MEMORANDUM

Project: Peer Review of Trail Projects – Capital Crescent Trail and Silver Spring Green Trail

Re: Assessment of bicycle and pedestrian issues along the Purple Line corridor

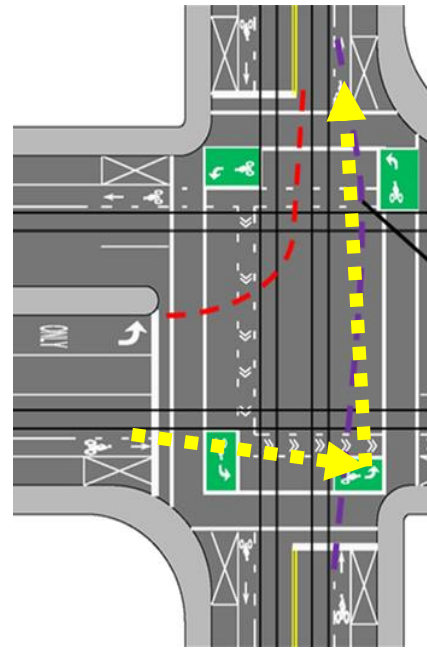
- In general, wherever bicycle use of a street with embedded tracks is legal, it should be expected and designed for. Use pavement markings and signage to facilitate safe track crossings. According to the AASHTO Bike Guide, the skew angle between the centerline of the tracks and the path of the bicycle should ideally be 90 degrees, but can be as low as 60 degrees to facilitate safe bicycle crossings. At all intersections, evaluate the angle at which each movement from each leg of the intersection (left, through, and right) crosses the tracks. If the crossing angle could be less than 60 degrees, use shared-lane markings to guide cyclists across tracks at an angle between 60 and 90 degrees. At some locations, it may be necessary to provide additional width for the cyclist to achieve this (see figure above).

If a 60-degree (or better) crossing is not possible, identify an alternative route and direct cyclists to it using signs. For instance, a two-stage left turn (aka crosswalk left) where the cyclists cross the street on the right side and wait in a bicycle box on the far side of the street to make a second crossing using the perpendicular crosswalk or the right hand travel lane to complete the left-turn maneuver (see dashed yellow line in figure at the right).

Connecticut Avenue Station (Master Planned Street B-1)

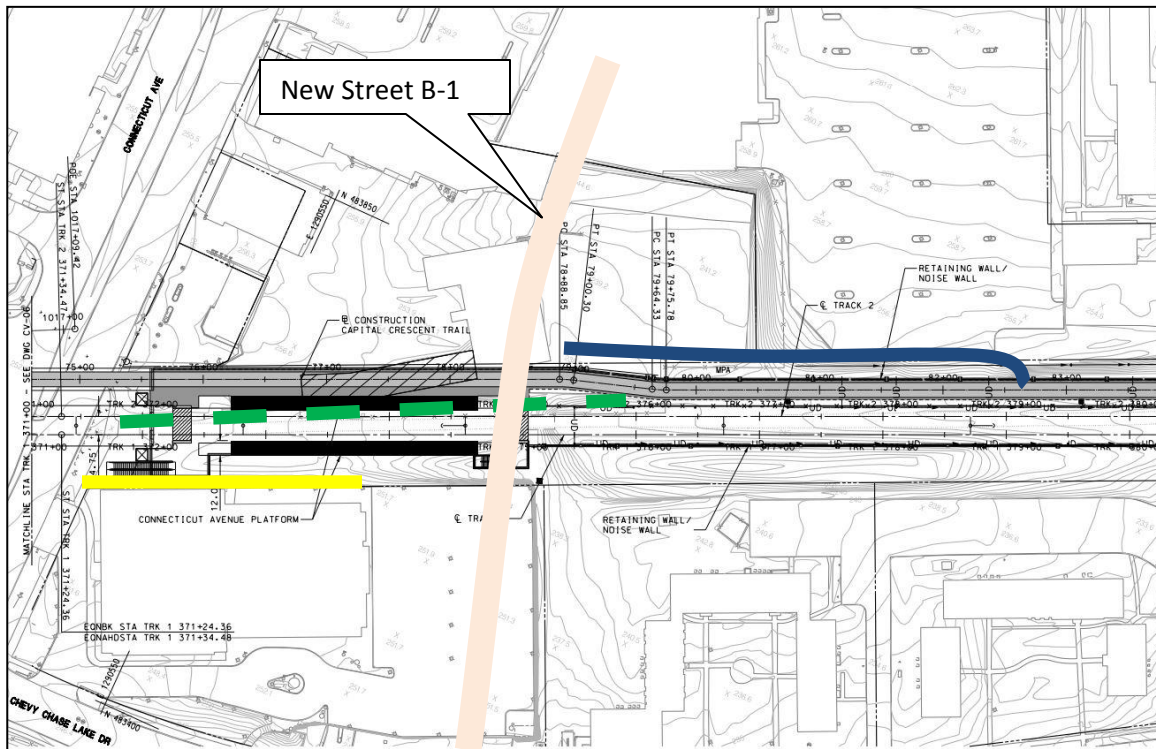
From an urban design and access point of view, TDG recommends that the Connecticut Avenue station be built on piers. This will create ground level space under the station tracks and platform which can be programmed as a plaza that provides a link from Connecticut Avenue to the new Street B-1, as well as a link between existing or redeveloped properties immediately north and south of the station. An open area can provide a space for covered bicycle parking and will create a more attractive, active and secure pedestrian environment at this station. An open area under the platform will provide more flexibility in future design of the following access links that are highly desirable, but can be constructed in conjunction with future redevelopment, including the following:

1. A ramp, linking to the trail at the east of the platform; if the ramp is not built by the project, space for it, and a trail tie in point should be provided so that the County or a future developer could build it (green dashed line).
2. A path link from Connecticut Avenue to the City Bikes store's deck and entrance on the ground level of the Chevy Chase Bank Building (yellow line).

If the station is built on fill with retaining walls, it would be prudent to design this support structure to easily allow for a future B-1 road (at its master planned width) to be constructed at a later date.

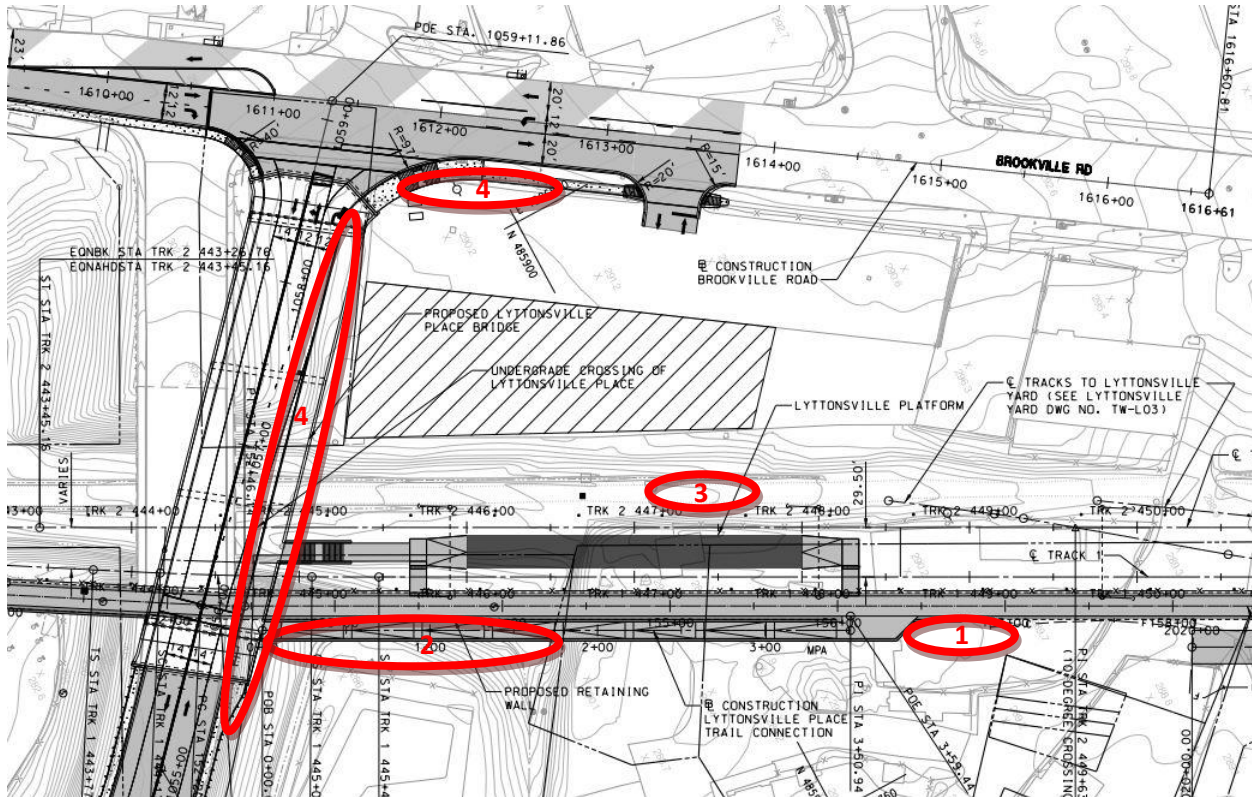
- Lyttonsville Bridge Cross Section:** The proposed bridge appears to provide 66 feet of travel space between the side walls/railings. To achieve the cross section

recommended by M-NCPPC without increasing the width of the bridge, TDG suggests the following cross section:

Use	Width (feet)
West Sidewalk	7
SB Bike Lane (including gutter pan)	6
SB Travel Lane	12
NB Travel Lane	12
NB Bike Lane (including gutter pan)	6
NB Bus Pullout	11
East Sidewalk/Shared-Use Path	12
Total	66

Because the tree buffer on the east side of Lyttonsville Place is not continued on the bridge, the east sidewalk/shared-use path can be 12 feet rather than 8 feet wide. Because it is primarily an access path to the Purple Line, not a through path, the 12 foot width can also accommodate bus shelters or benches for the waiting area and provides additional mixing capacity for the pedestrians and bicyclists accessing the CCT and Purple Line Station. The bike lanes on the bridge are 6 feet wide to provide bicyclists the opportunity for greater separation from adjacent buses when they are stopped to pick up/drop off transfer patrons.

Sligo Creek Trail

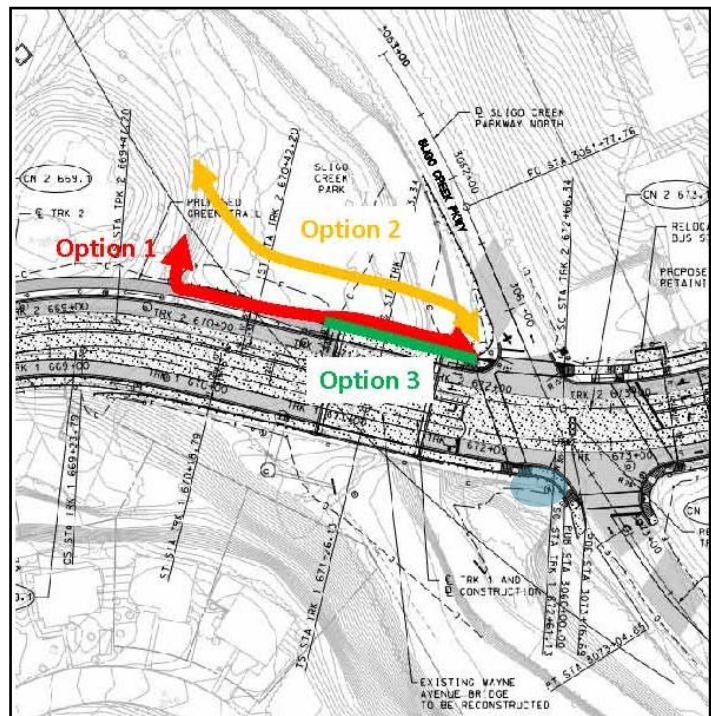
A number of issues exist with the current design of the Silver Spring Green Trail's linkage to the Sligo Creek Trail, and the trail's crossing of Piney Branch Road. They include the following:

1. A lack of sufficient trail width and buffer (not AASHTO standard) from the Sligo Creek Trail where it meets Wayne Avenue from the north to the bridge, across the replaced bridge, and to the intersection of Wayne Avenue and Sligo Creek Parkway. This section of the trail is essentially on the sidewalk today, and is unimproved by the Purple Line project.
2. A lack of improvement to the Sligo Creek Trail crossing of Wayne Avenue.
3. A lack of improvement to the Sligo Creek Trail on the south side of Wayne Avenue.
4. A lack of aesthetics in the design of the bridge as a gateway to Silver Spring and homage to the natural feature of Sligo Creek and Sligo Creek Park and Trail.

TDG concurs with the concerns raised by Planning Staff. Additionally, TDG is aware that the Sligo Creek Trail was designed many years ago. In its current condition in this area, it is substandard in width, and it appears that the Purple Line project is not bringing the parts of the trail impacted by the project up to current standards. It is a best practice to have every capital transportation project improve the other transportation facilities in its area of impact. The Sligo Creek trail is expected to be a major feeder of bicycle and pedestrian traffic to the Purple Line, thus the Purple Line will result in increased trail traffic which the project should accommodate. Moreover, improving a portion of the Sligo Trail will encourage its use for Purple Line access and help ensure that Purple Line ridership projections are met.
